RENESAS TECHNICAL UPDATE

Product Category	MPU&MCU		Document No.	TN-WRP-A011A/E	Rev.	1.00
Title	Replace of Shipping Tray Type for 17x17mmSQ-BGA Packages		Information Category	Packing Change		
Applicable Product	Device of SH-MPU and CBIC which has applied below the Package-Code. Package-Code:BP-256B,BP-256BV,BP-336, BP-336V,BP-256H,BP-256HV,BP-300,BP-300V,PRBG0292GA-A,PRBG0256GA-A,P LBG256GA-A	Lot No.	Reference Document	None

Comparative outline

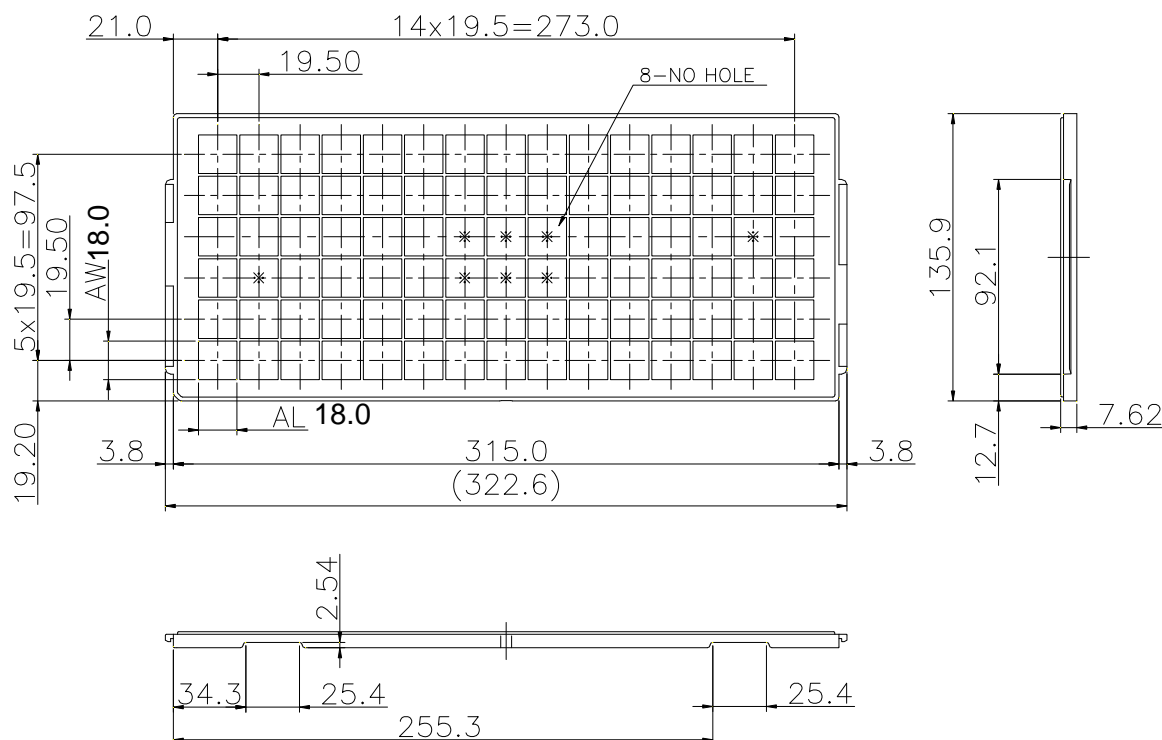
The appearance of the pockets and the size of the open pockets change a little.

Please refer to the table below. However, because it is a tray based on the JEDEC standard, the pitch between externals size, the number of pockets, and the pocket doesn't have the change.

In addition, PTB75C and PTA36CF tray can be used even if it piles it. Therefore, the inconvenience in customer's mounter is not and can be used. A detailed size is shown on the subsequent page.
